WIDE ACRES SUBDIVISION, **RESUBDIVISION OF LOT 38**

APPLICATION NUMBER 6 DATE April 16, 2015

DETAIL SITE PLAN

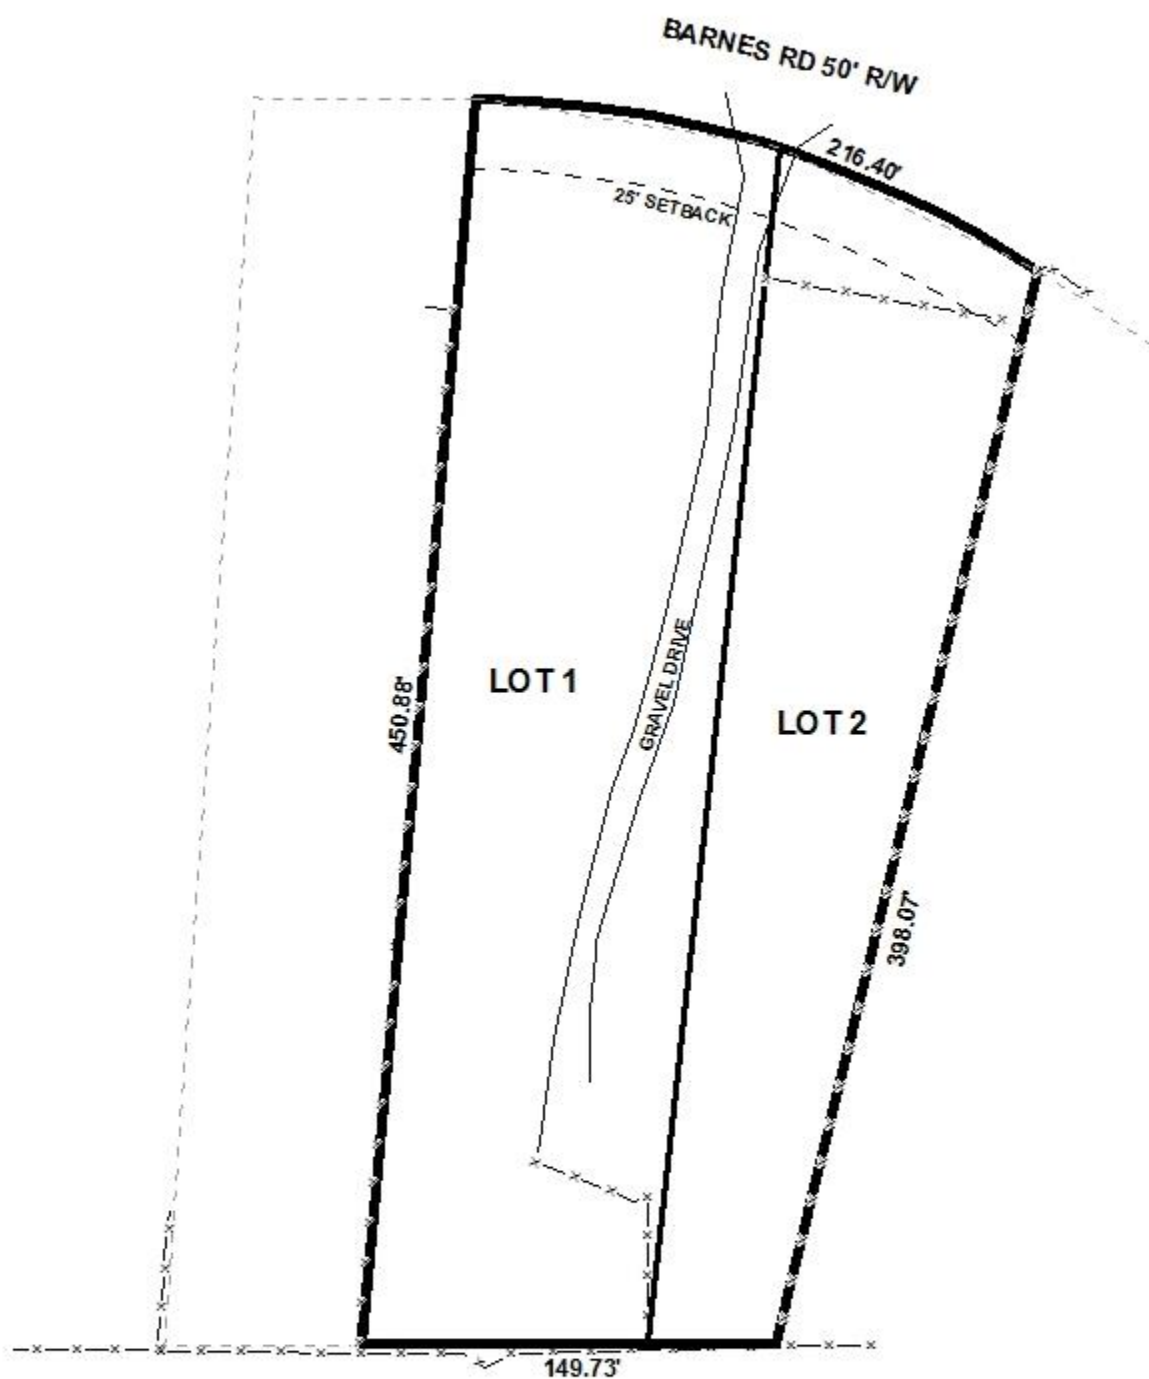
The proposed lots front Barnes Road, a paved minor street with asphalt curb and gutter, which requires a 50' wide right-of-way width. The preliminary plat depicts an existing right-of-way width of 50', thus no dedication is required.

The existing site is currently developed with what appears to be three dwelling units with a shared driveway. As a means of access management, a note should be placed on the Final Plat stating that the proposed Lot 1 should be limited to the existing curb-cut to Barnes Road and the proposed Lot 2 is limited to 1 curb-cut to Barnes Road. The size, design and location of the new curb-cut, and any changes to the existing curb-cut, are to be approved by Mobile County Engineering and conform to AASHTO standards.

In accordance with the Subdivision Regulations, both proposed lots appear to exceed the minimum lot size requirements; however, both lots will need a waiver of Section V.D.3 of the Subdivision Regulations as their depth appears to exceed 3.5 times the width of the lot at the building setback line. The lot size information should be revised to include both acres and square feet on the Final Plat, if approved.

The 25' minimum building setback line is also depicted on the preliminary plat, and should be retained on the Final Plat, if approved.

This site is located in the County, therefore any lots which are developed commercially and adjoin residentially developed property must provide a buffer, in compliance with Section V.A.8. of the Subdivision Regulations. A note so stating should be placed on the Final Plat, if approved.

- 1) Placement of a note on the Final Plat stating that Lot 1 is limited to the existing curb-cut to Barnes Road, with any changes to the size, design and location to be approved by Mobile County Engineering and conform to AASHTO standards;

- 2) Placement of a note on the Final Plat stating that Lot 2 is limited to 1 curb-cut to Barnes Road, with the size, design or location to be approved by Mobile County Engineering and conform to AASHTO standards;

- 3) Revision of the lot size information to include both acres and square feet on the Final Plat;
- 4) Retention of the 25' minimum building setback line on the Final Plat;

- 5) Placement of a note on the Final Plat stating: *(This site is located in the County, and therefore any lots which are developed commercially and adjoin residentially developed property must provide a buffer, in compliance with Section V.A.8. of the Subdivision Regulations.);*
